Transdev Services, Inc. Addendum No. 4 RFQ NO.V2396 One (1) On-Road Service Truck

Service Truck V-2396

Enclosed Service Body Dimensions

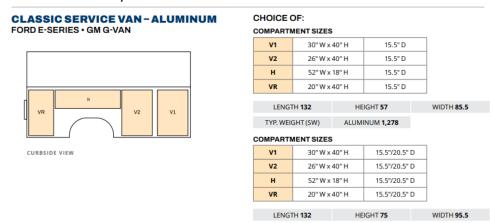
• The spec calls for 2 different types of bodies; an 11' enclosed body for a cutaway van, and a 9' open utility body with topsider toolboxes for a cab chassis (see below). Could you please advise which of the two you would like quoted?

We are seeking a NICE bus-preferred 132 inches (11-foot) enclosed service body, rather than an open utility body, to accommodate and shelter our lube skid and air compressor. The top-side toolboxes should be positioned above the rear wheel line or follow a standard configuration. An example of the body would be the Classic Service Van Body, Reading model #CSV 75-SW, Aluminum Construction or a NICE bus-approved equal that meets or exceeds the specified salient characteristics

132in. overall length of enclosed service body

48 1/2 in. wide rear door opening

85 1/2 in. overall width

75 in. inside overall height

86 ½ in. outside height (from bottom of service body)

48 ½ in. floor width With rear access doors
